**RE: Supplement #1 to Technical Drainage Study for JP Morgan Chase:
Chase @ Maryland & Sahara
(HTE: 10-27576)**

TECHNICAL DRAINAGE STUDY
CHASE @ MARYLAND & SAHARA
CLARK COUNTY

SUPPLEMENT #1 to the **TECHNICAL DRAINAGE STUDY** for

**JP MORGAN CHASE
CHASE @ MARYLAND & SAHARA
APN: 162-11-101-001**

Cross Section for SECTION 1-SAHARA 100-YR

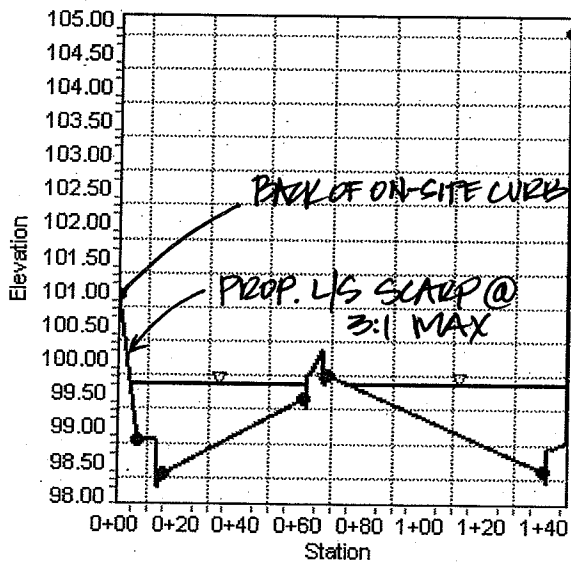
Comment 1: According to North Section B on sheet G1 and the top of curb elevations provided, it looks like the proposed curb along Sahara Avenue will be raised. This curb, roughly 3.5'-4.5' from NDOT Right-of-Way, will constrict the flow path in Sahara and in doing so may raise the water surface elevation over Sahara Avenue, increasing the hazard to the traveling public. Please address.

The FlowMaster section for *SECTION 1-SAHARA 100-YR* that was included in the original study was a section of the existing street section with the proposed landscape adjacent to the existing sidewalk scarping up to the new proposed on-site improvements. I've included the section in **Appendix B** for reference.

In the existing conditions before this proposed project, the depth of flow in Sahara is **1.52'**. The depth of flow after the development of this project and landscape scarping is **1.51'**. **The entire street is inundated with water in existing conditions in the 100-year storm event and the development of this project site does not increase flows to the NDOT Right-of-Way nor does it adversely affect the existing conditions.**
